MAINE TURNPIKE AUTHORITY

ADDENDUM NO. 2

CONTRACT 2026.02

PAVEMENT REHABILITATION AND
SAFETY IMPROVEMENTS
MM 27.4 TO MM 30.3

TYPICAL SECTIONS

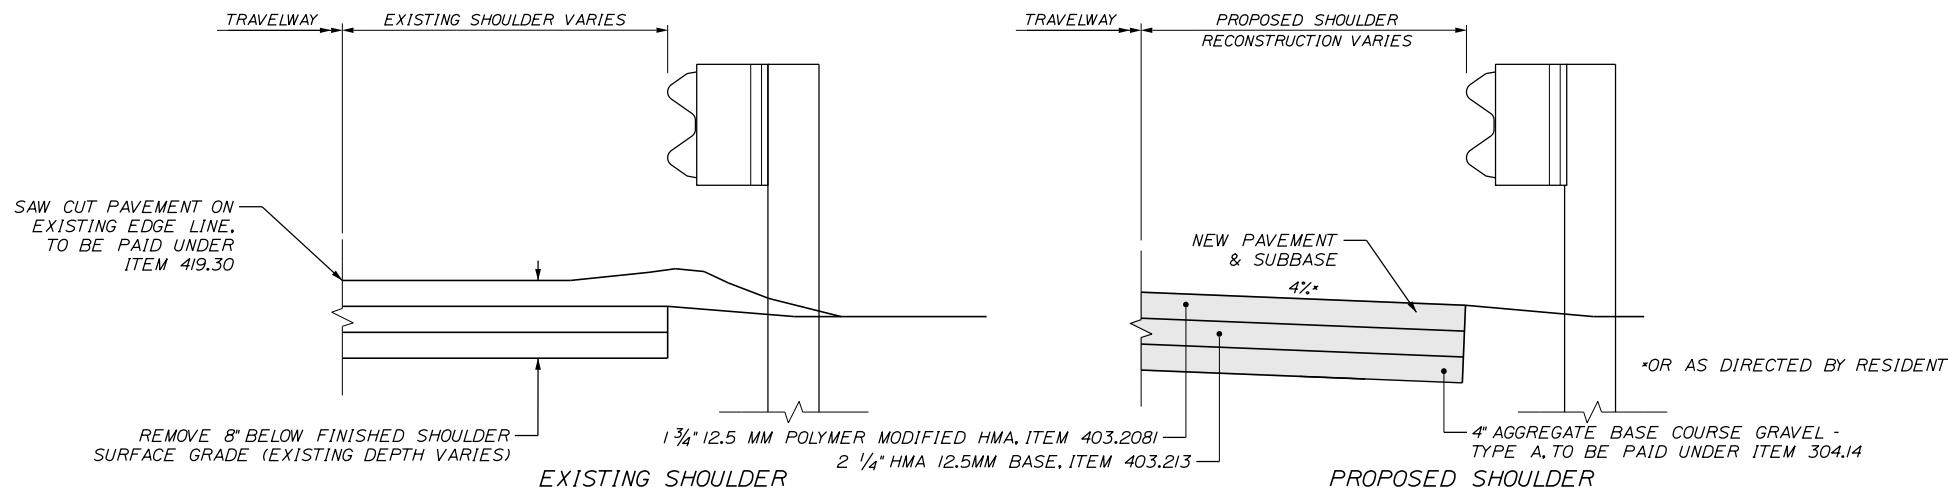
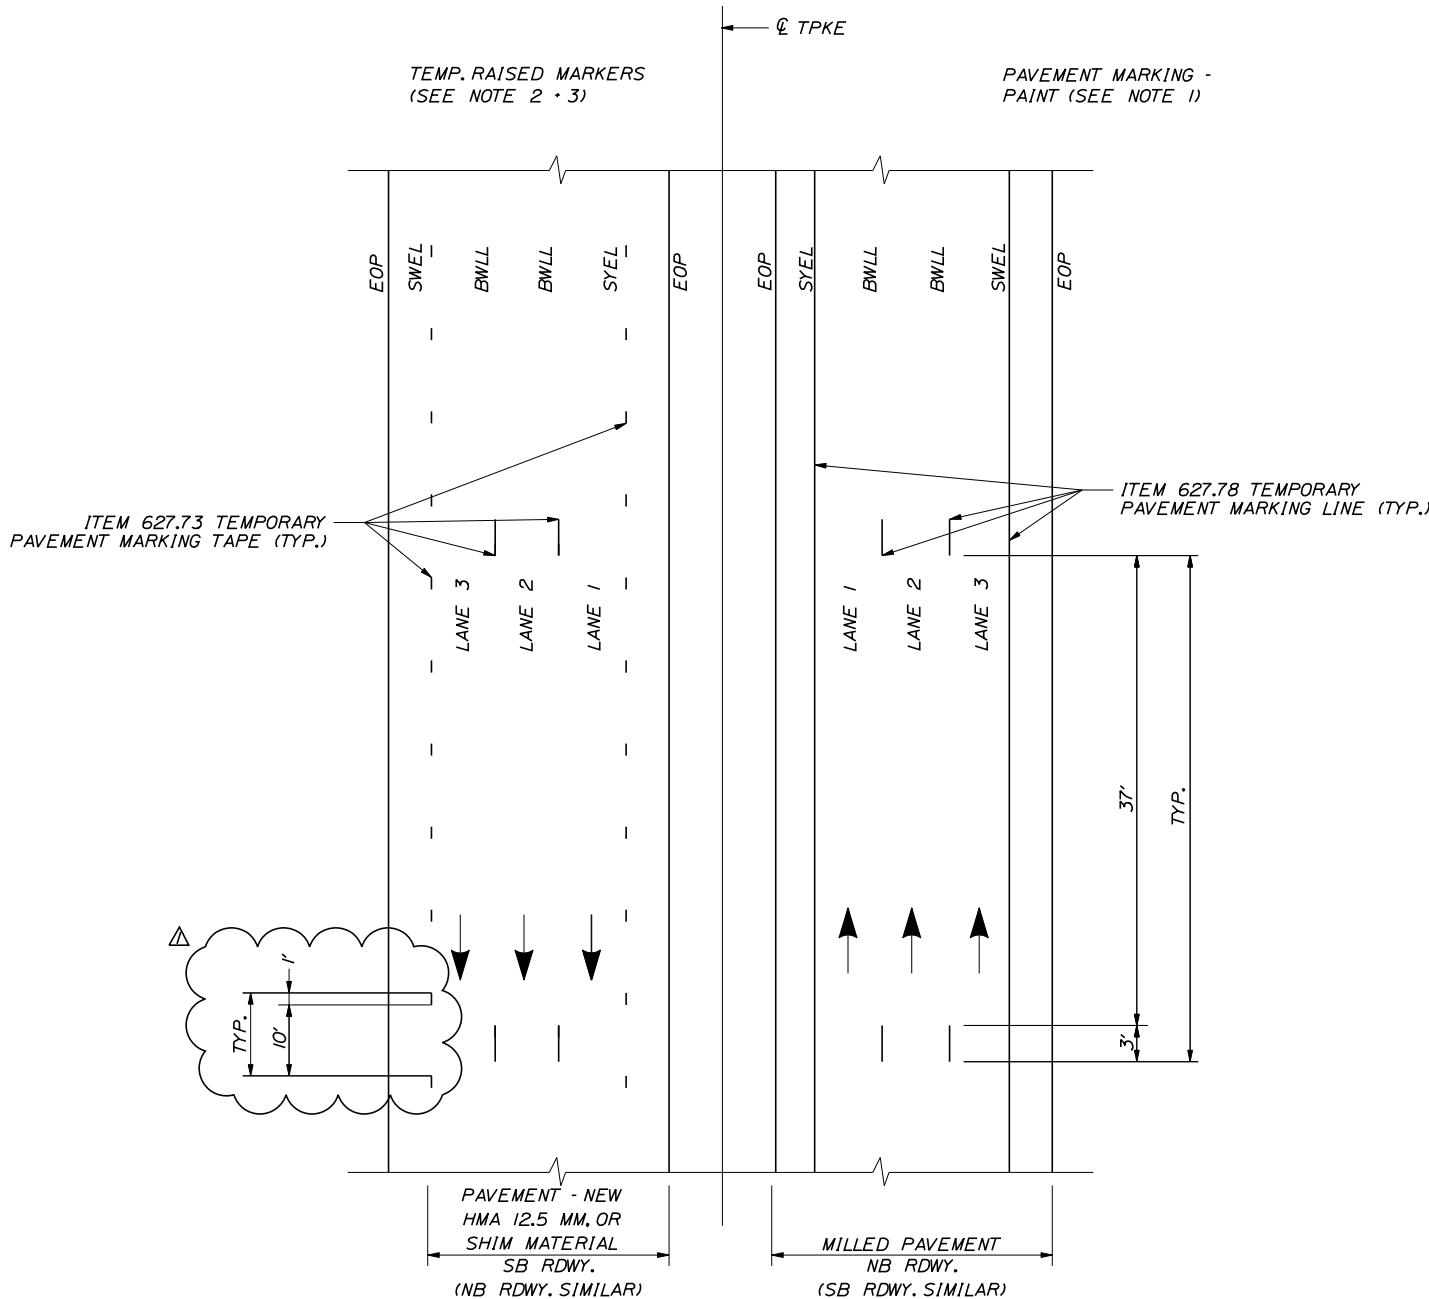
- Plan Sheet 2 Estimate Quantities & General Notes shall be replaced.
- Plan Sheet 4 Typical Sections shall be replaced to update wording about shoulder paving.
- Plan Sheet 8 Pavement Marking Details shall be replaced to update the length of temporary tape used to mark the outside lane edges.
- Plan Sheet 9 Catch Basin and Grooving Details shall be replaced to update the location and length of paint used to mark catch basin locations.

Lane 1 and the median shoulder shall be pulled as one. Lane 3 and the outside shoulder may be pulled as one.
